METROPOLITAN GOVERNMENT OF NASHVILLE AND DAVIDSON COUNTY

STAFF RECOMMENDATION
2216 Grantland Avenue
April 20, 2016

Application: New construction – addition
District: Woodland in Waverly Historic Preservation Zoning Overlay
Council District: 17
Map and Parcel Number: 10514011100
Applicant: Colin and Lara Mead
Project Lead: Paul Hoffman, paul.hoffman@nashville.gov

② WEST ELEVATION 11X17
1/8" = 1'-0"

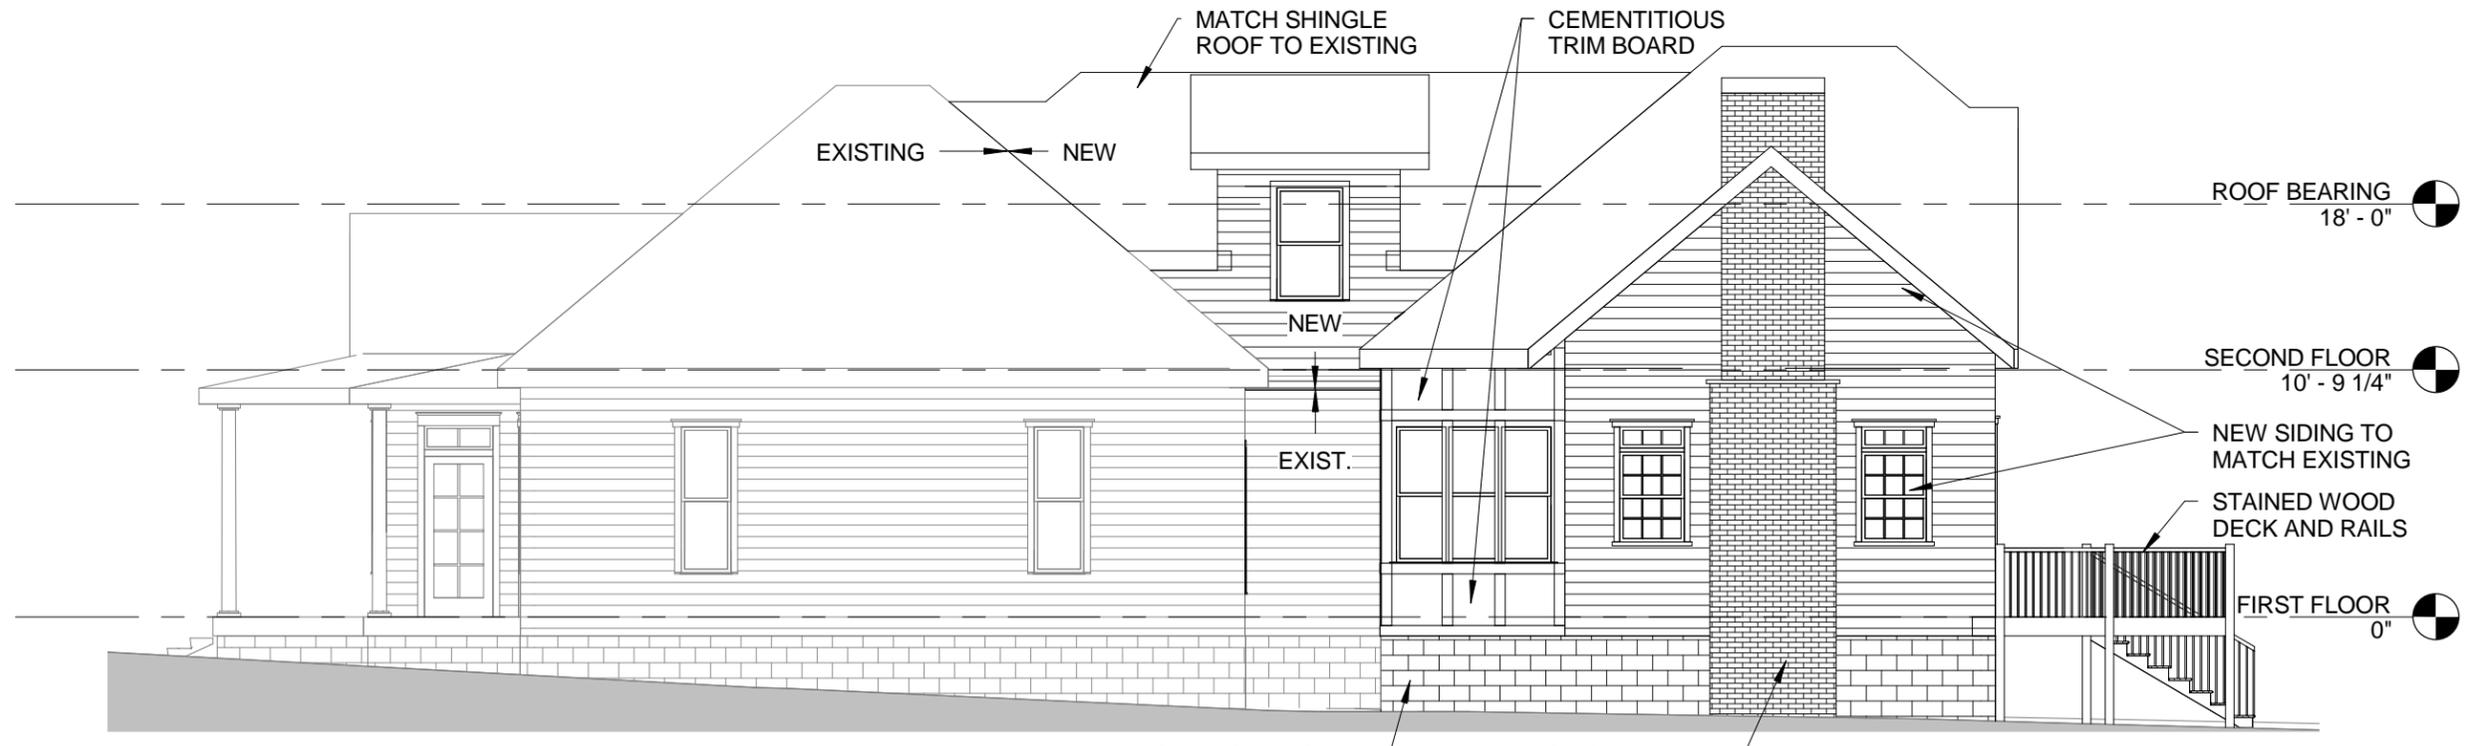
Materials, Texture, and Details and Material Color: The addition will be clad in horizontal lap siding with a reveal matching the existing siding. The siding material was not specified; staff recommends as a condition of approval that the siding be wood or smooth-faced cement fiberboard. A section of the addition's right side will be fiber cement board-and-batten. The trim will be wood or cement fiberboard. The foundation will be concrete block. The window and door materials and model were not specified; staff recommends final approval of all windows and doors prior to purchase and installation. A rear deck will have wood deck, rails and steps. The chimney will be brick; Staff requests approval of a masonry sample. With the approval of masonry, roof color, windows and doors, and siding, staff finds that the materials meet Section III.B.1. and III.B.2.d of the design guidelines.

Roof Form: The historic house has a cross gable and hipped roof form. The addition has different roof forms, including a clipped roof with 10/12 pitch over a rear-facing gable, and shed dormers with 4/12 pitch. One of the dormers is a wall dormer, which is typically not appropriate but staff finds that in this case it will be minimally visible and not accentuate height. The proposed roof forms are commonly found in the neighborhood, and staff finds that the proposed roof forms are compatible with the historic house's roof and meet Sections III.B.1. and III.B.2.e. of the design guidelines.

Proportion and Rhythm of Openings: The windows on the addition are largely twice as tall as they are wide, thereby meeting the historic proportion of window openings. The longest expanse without a window opening is approximately ten feet (10') on the left side. The windows and door on the rear façade include transoms. Staff finds the addition's proportion and rhythm of openings are compatible with surrounding historic buildings and meet Section III.B.2.g. of the design guidelines.

1. Lap siding shall be wood or smooth-faced fiber-cement siding;
2. Staff approve window and doors;
3. Staff approve the roof material, color, and texture;
4. Staff approve masonry.
